SANDY SPRINGS

P&Z STAFF REPORT

Board of Appeals Hearing; March 12, 2019

Case: **V19-0003 – 501 Brookfield Drive**

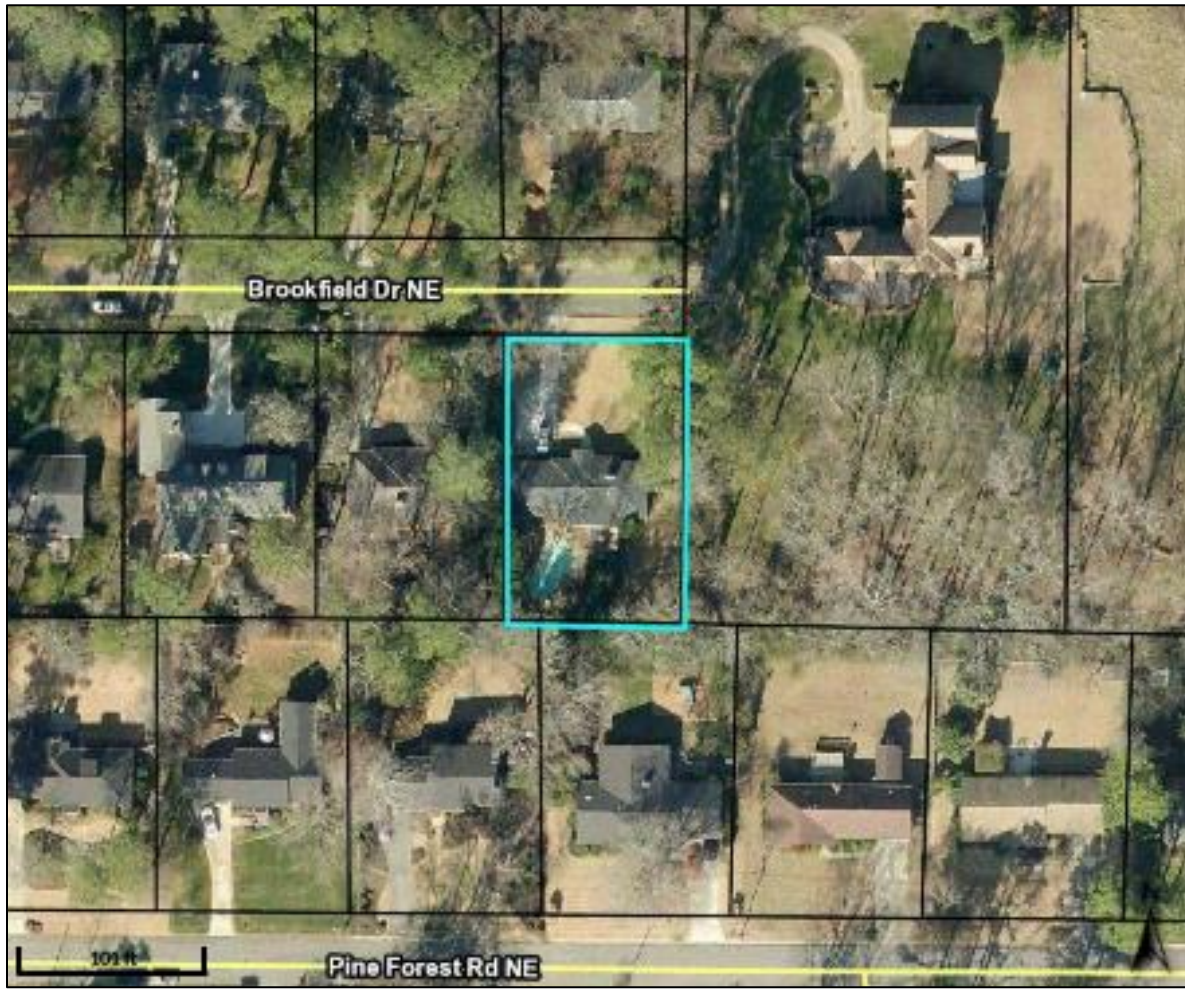
The applicant is requesting two variances. One request is to allow for the enclosure of an existing carport that encroaches into the side setback and also allow an additional encroachment of approximately 100 square feet into the required side setback for the

construction of an attached one-car garage. The second request is to allow the proposed one-car garage to extend approximately 9 feet beyond the front wall plane of the house. The front wall plane is defined as the building facade facing the primary street right-of-way or if the facade is articulated, the front wall plane is the wall of a conditioned space closest to the right-of-way.

Encroachment of Carport:

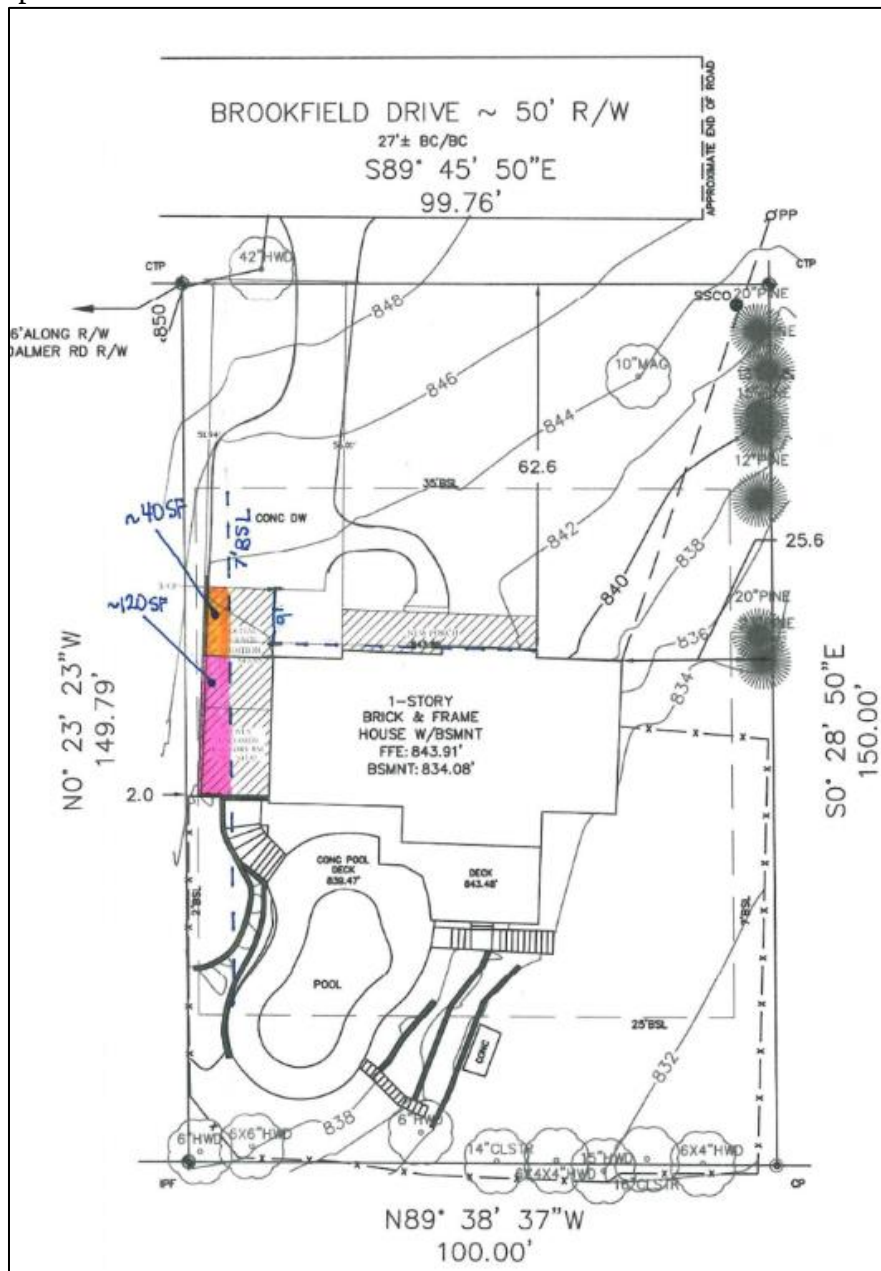
The lot meets the lot width and lot area standards for the RD-12 zoning district. The existing house meets the setback requirements, but the carport encroaches into the required 7 foot side setback by 5 feet. Approximately 120 square feet of the carport encroaches into the required side setback.

Because neither the lot configuration nor the topography are considered extraordinary or exceptional, staff does not recognize a hardship.
